PROJECT REFERENCE NO.	SHEET NO.
U-4405	UC-17
DESIGNED BY: AMH	8/3/2018
DRAWN BY: AMH/AB	NORTH CAROLINA PROFESSIONAL ENGINEER SEAL 025490
CHECKED BY: AMH	MARK W. FISHER
APPROVED BY: MWF	ENGINEER
REVISED:	PLANS ONLY
NORTH CAROLINA DEPARTMENT OF TRANSPORTATION	
UTILITIES ENGINEERING SEC. PHONE: (919) 707-6690 FAX: (919) 250-4151

UTILITY CONSTRUCTION

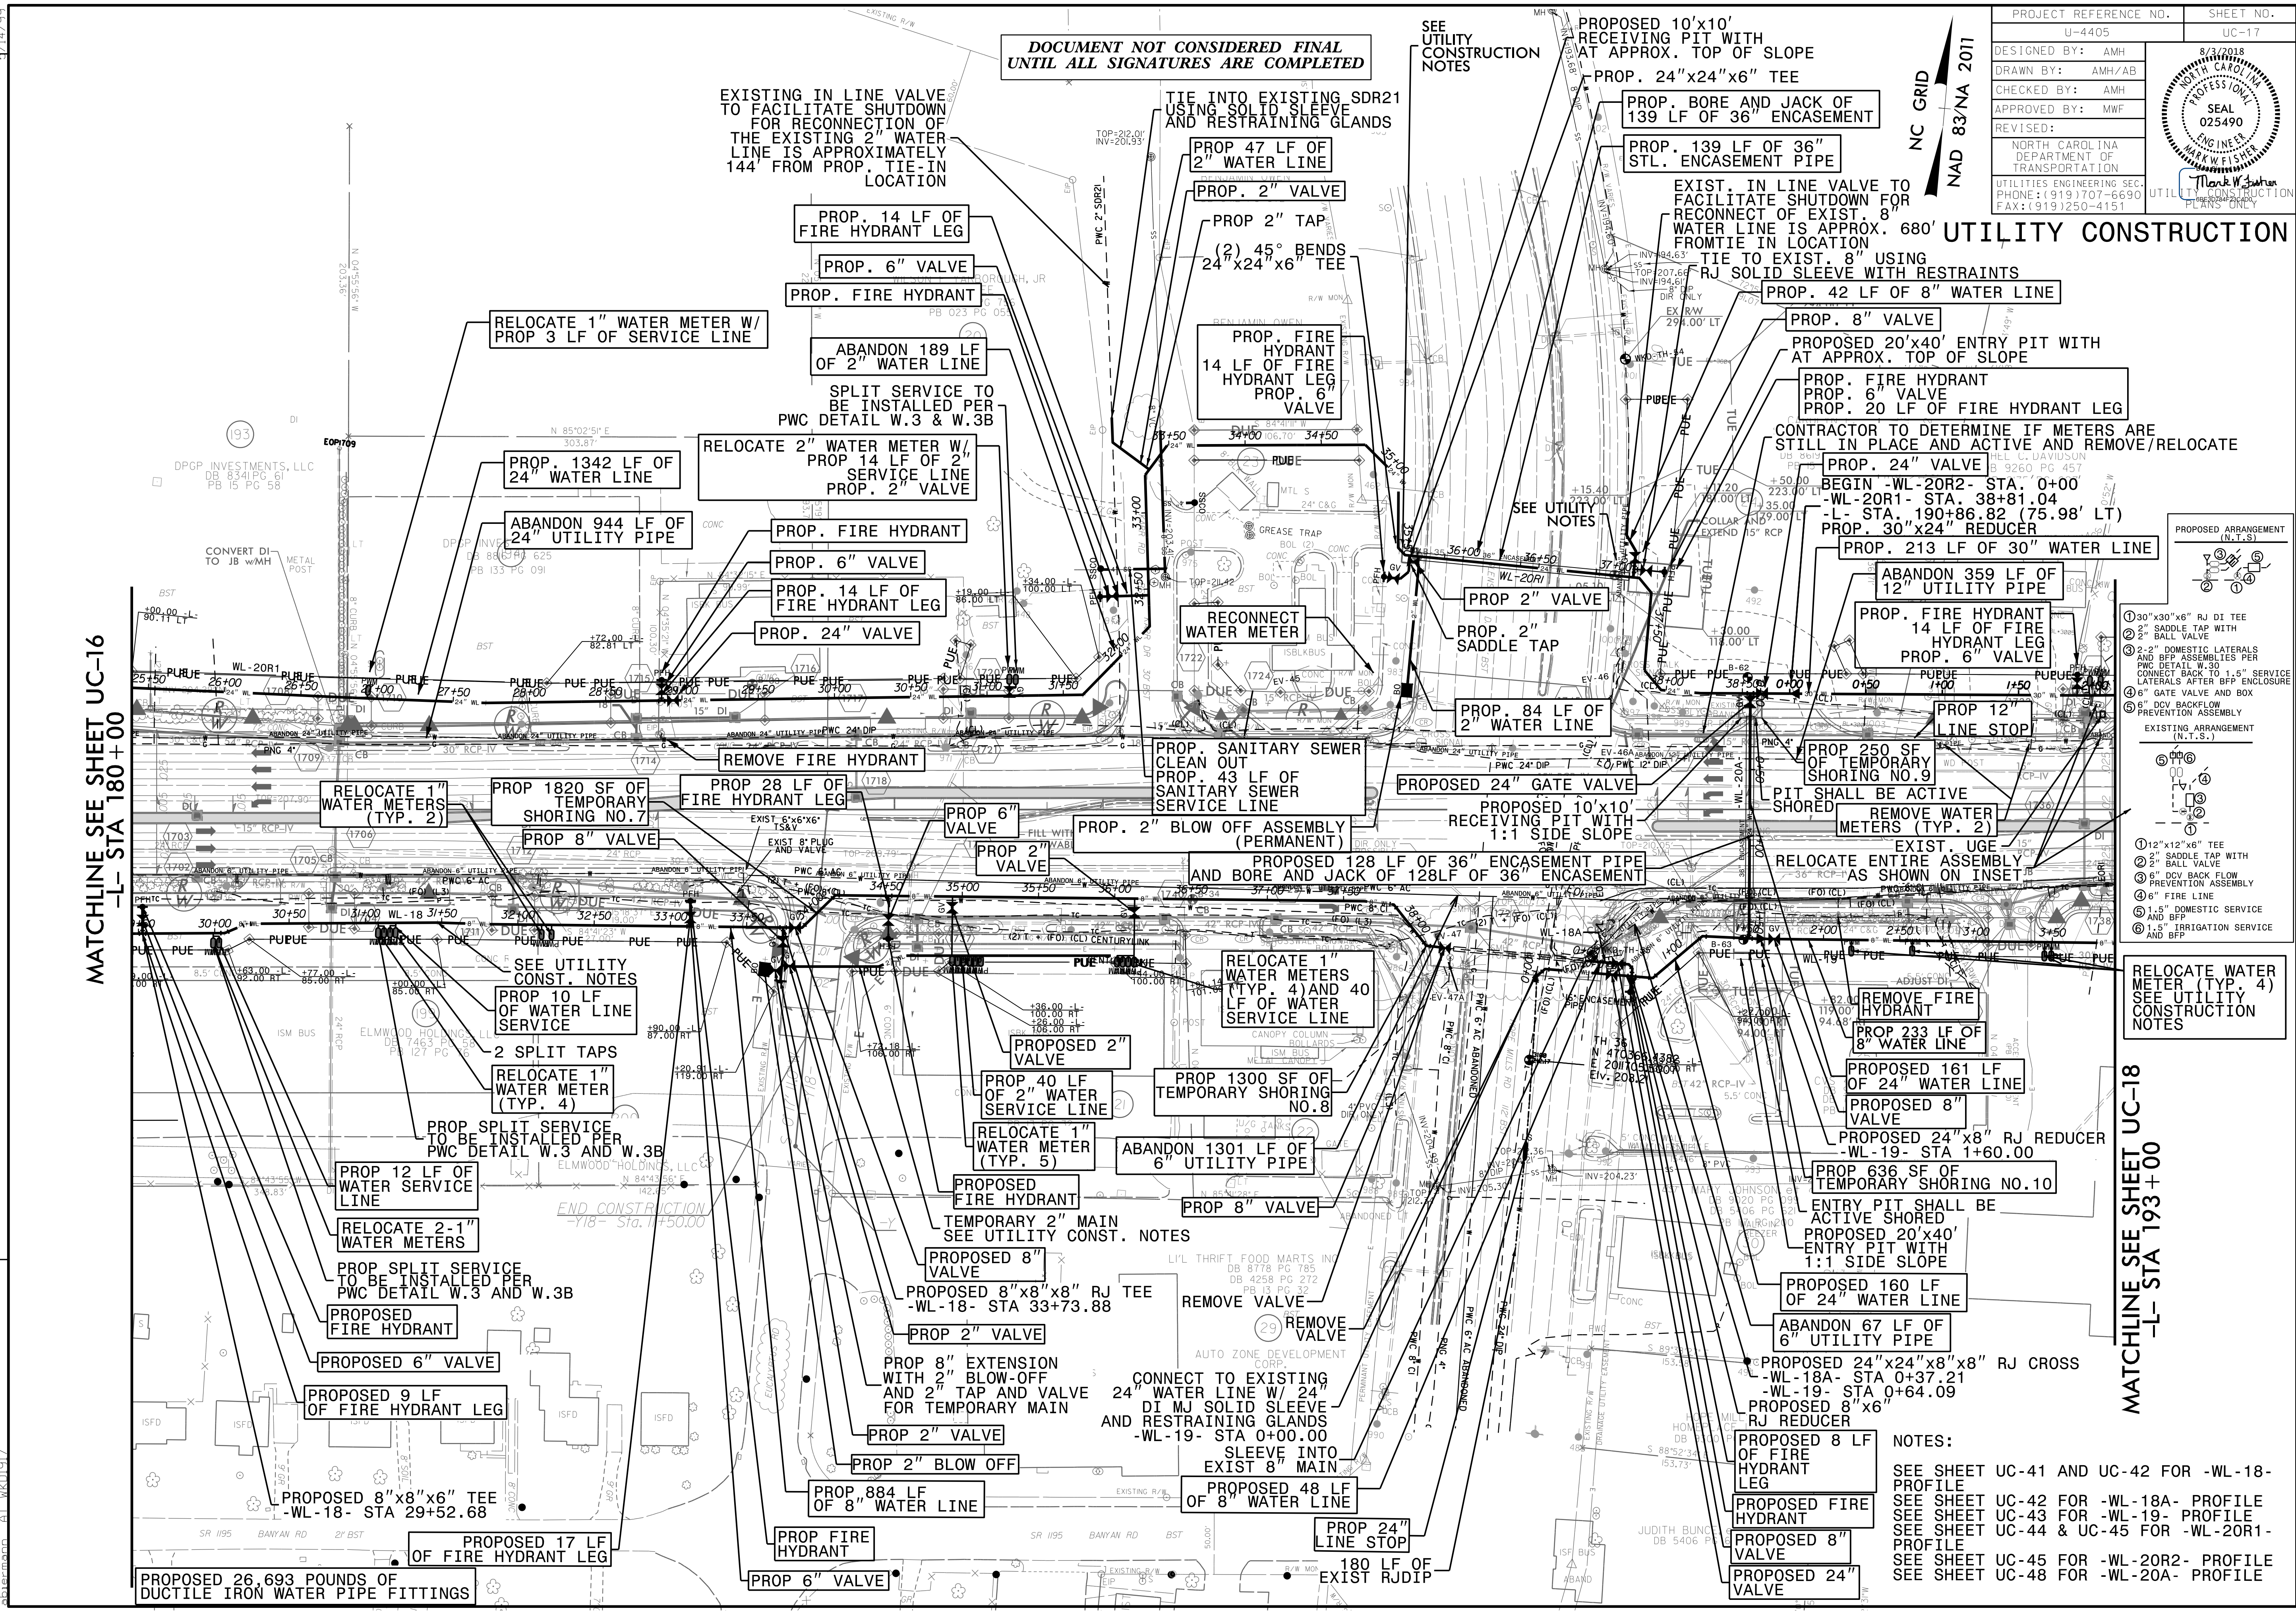
UTILITY REV. - JULY 23, 2018 - ADDED A SANITARY SEWER SERVICE RECONNECTION ON KARR DR FOR PARCEL 23  
- ADDED 12" DI 150' FOR CONSTRUCTION SEQUENCE  
- ADDED A 12" LINE STOP IN FRONT OF THE CIRCLE & FOR CONSTRUCTION SEQUENCING
